ADDENDUM #1

Project Name:
Capitol West Stairs & Surrounding Landings Repair - Bid Issuance #3
DAS# 9420.00
RFB 942000-01
Addendum #1
Dated: July 31, 2025

ADDENDUM #1

PROJECT: 9420.00 DAS CC Capitol West Stairs & Surrounding Landscape Repairs Bid Issuance #3

E6 SITE ACCESS FIRST LEVEL FLOOR PLAN - E / W
1" = 50'-0"

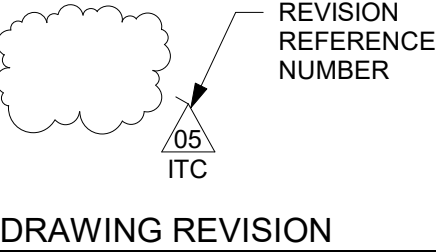
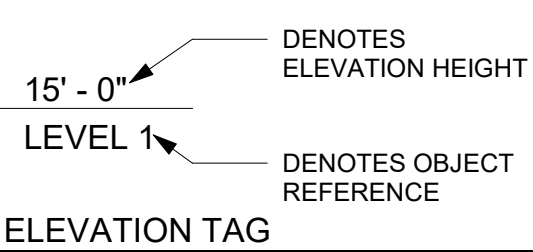
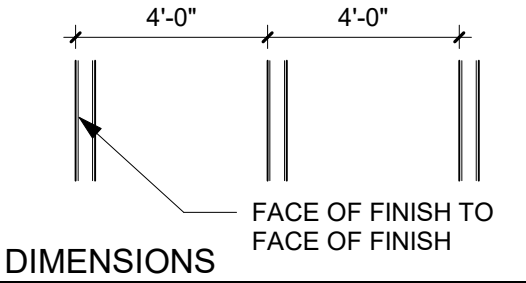
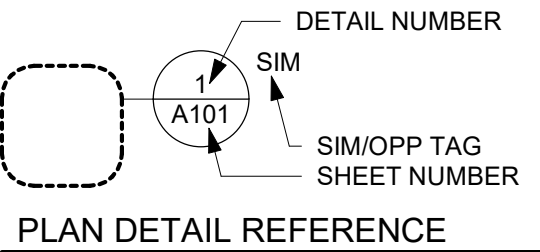
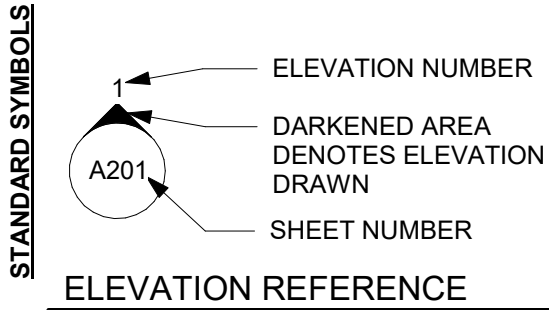
Item #	Sheet #	Description of Change
1.	A000.3	Detail E6 A. Clarification - Will the contractor lay down area shown on A000.3 be available for parking? Answer - yes, but only two vehicles. B. Will the lay down area be available during the Legislative Session time frame or will all materials need to be removed? No, This area will not be

<p>available during the Legislative Session. Contractor will need to clean and remove materials by December 1, 2025 and will be likely be available sometime in May 2026 after the Legislative Session. This date is not known but next the session is scheduled for approximately 100 calendar days.</p> <p>C. See attached drawing of A000.3</p>
